DATE: 8-2-16

APPLIES TO: This service bulletin applies to 2015 and 2016 model year, K2, K3, and MM model motorhome chassis built between October 2, 2013 and October 12, 2015 by Spartan Motors USA, Inc.

CONDITION: Rear suspension cross member may be missing fasteners.

FIG. 2-2

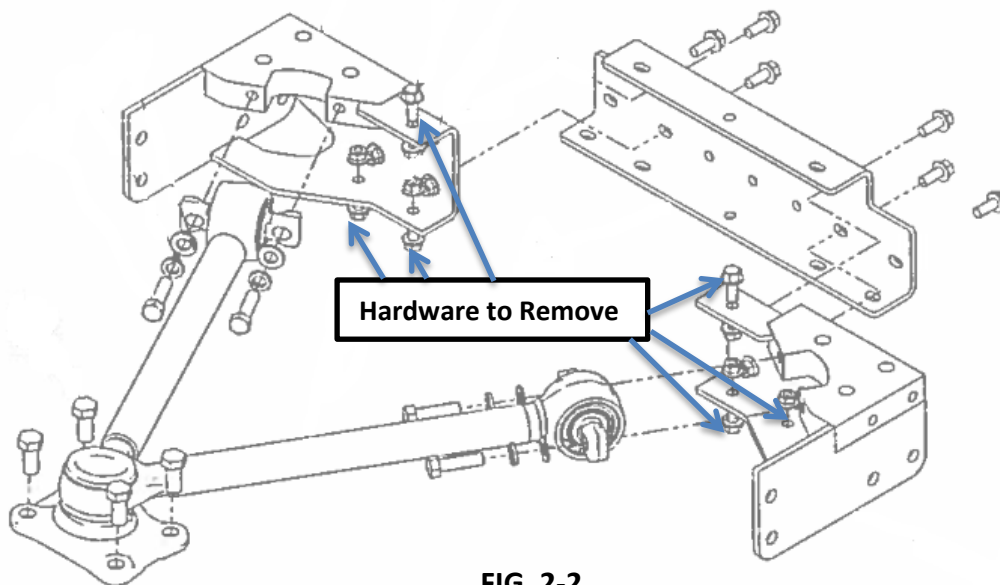
2. Remove 6 existing bolts and nuts and properly dispose of hardware. Refer to FIG. 2-2.

FIG. 3-1

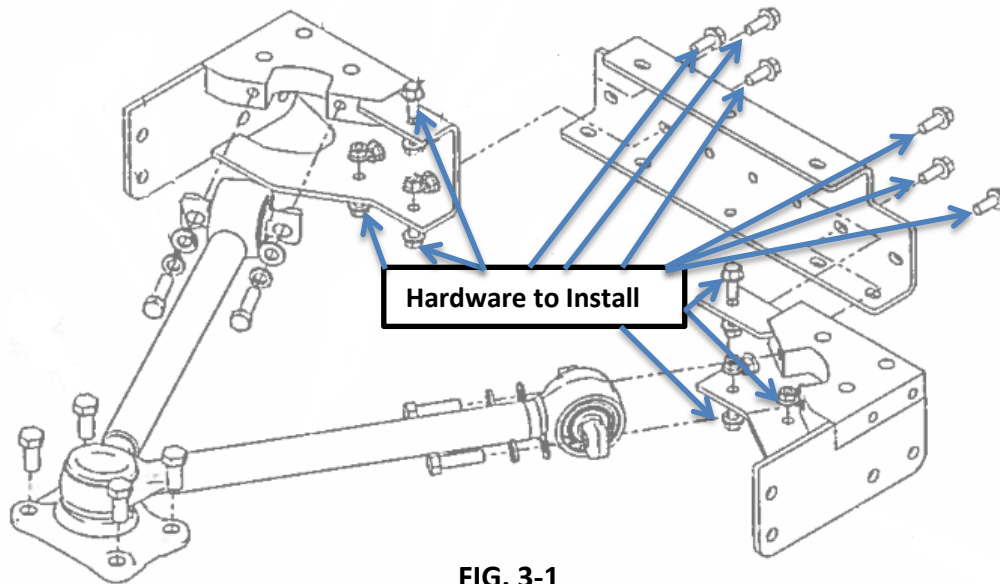
3. Inspect V-Rod cross member for any damage. Replace any damaged parts.
4. Install supplied hardware as shown in FIG. 3-1.

Note: Due to access based on body builder basement location, the fasteners may need to be installed from the other direction.

5. If the hardware can be installed as in FIG. 3-1, torque the nut side to 80 ft.-lbs.
6. If the hardware cannot be installed as shown in FIG. 3-1, and has to go the opposite direction, torque the bolt side to 93 ft.-lbs.
